Bearing Carrier Nut Low Torque – 90/120

Force

1997 90/120

S/N 0E262167 thru 0E264177

a - Nut Torque 25 lb. ft. (33.9 N·m)

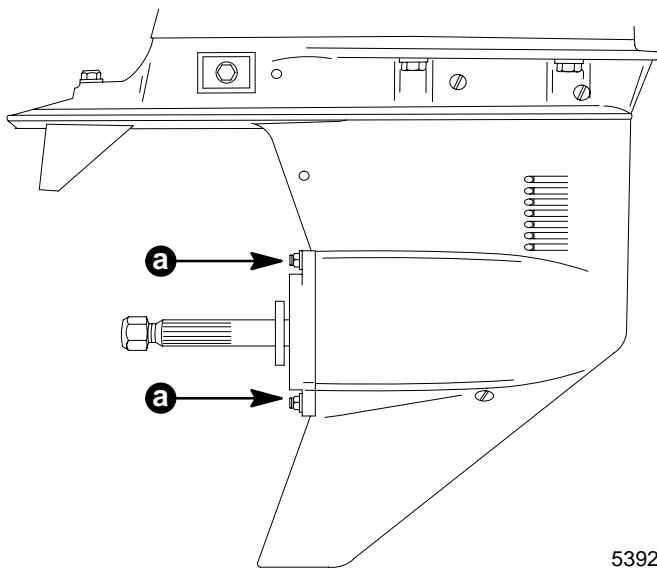
A small quantity of bearing carrier nuts on the models listed were torqued below specification during assembly. On these models, the bearing carrier may become loose and eventually fail the gearcase. It is necessary to retorque the bearing carrier nuts to the specified torque of 25 lb. ft. (33.9 N·m).

Loosen each bearing carrier nut, one quarter turn, and retorque to 25 lb. ft. (33.9 N·m). Paint the end of the stud/nut white for repair identification.
